# Access Compliance Report

## Public Rights-of-Way

### (Curb Ramps)

Intersection ID: 53380	Main Street: IKEA_BV	Cross Street: LEWIS_ST	Location: W
ADA ID: 2286CFDE6F7D	Ramp Type: Perp	Initial Pass/Fail: Pass	Overall Compliance: No
Severity Score: 5			
Codes/Mitigation Info/Possible Solution		Field Measurements/Component Compliance

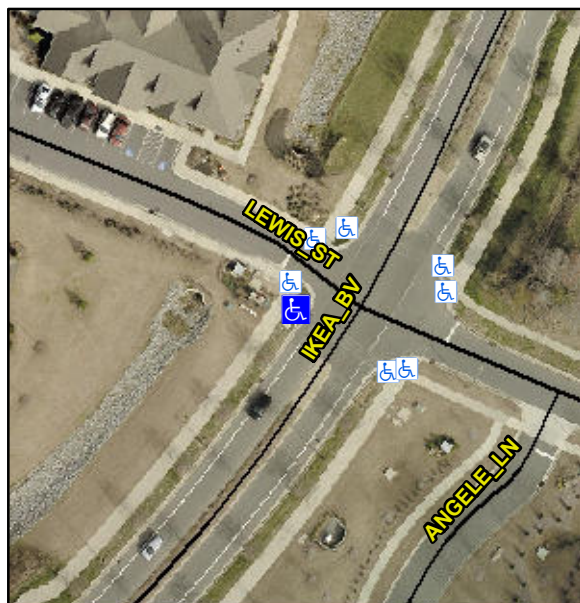
**Not Found, R302.7, R304.5.4**

Compliance	Description	Data	Compliance	Description	Data
N/A	Ramp Length (in)	95.0	Yes	Ramp Slope (%)	8.3
Yes	Ramp Width (in)	59.0	Yes	Ramp XSlope (%)	0.6
Yes	Flare Type L	Curbed_NoWalkSurface	Yes	Flare Type RT	N/A
Yes	Flare Slope LT (%)	N/A	N/A	Flare Slope RT (%)	N/A
N/A	Flare Traversable LT?	No	N/A	Flare Traversable RT?	No
Yes	Landing Length (in)	96.0	Yes	DWS Provided?	Yes
Yes	Landing Width (in)	71.0	Yes	DWS Contrast?	Yes
Yes	Landing Slope (%)	1.2	Yes	DWS Length (in)	24.0
Yes	Landing X Slope (%)	0.4	Yes	DWS Full Width?	Yes
N/A	Landing Curb? (Y/N)	No	Yes	DWS Offset (in)	1.0
N/A	Shared Landing?	Yes			
No	Gutter Ponding?	Yes	No	Gutter Slope (%)	6.0
Yes	Gutter Lip Ht (in)	0.0	Yes	Gutter X Slope (%)	2.6
N/A	Painted X Walk1?	Yes	N/A	Painted X Walk2?	N/A
	X Walk 1 Direction	To SE		X Walk 2 Direction	N/A
N/A	X Walk 1 Width (in)	60.0	N/A	X Walk 2 Width (in)	N/A
	X Walk 1 Slope (%)	2.4		X Walk 2 Slope (%)	N/A
	X Walk 1 X Slope (%)	3.3		X Walk 2 X Slope (%)	N/A

Yes	Ramp inside XWalk1?	Yes	N/A	Ramp inside XWalk2?	N/A
	Road Slope (%)	N/A	N/A	Clear Space?	Yes
	Road X Slope (%)	N/A	N/A	Clear Space to XWalk (in)	N/A
Yes	Any Obstructions?	No	Yes	Storm Grate/Utility Hazard?	No
	Obstruction Type			Storm Grate/Utility Type	
		N/A			N/A
			Yes	Surface Condition? (G/P)	Good

**Remove & Replace Entire Ramp.  
Remove & Replace Gutter.**
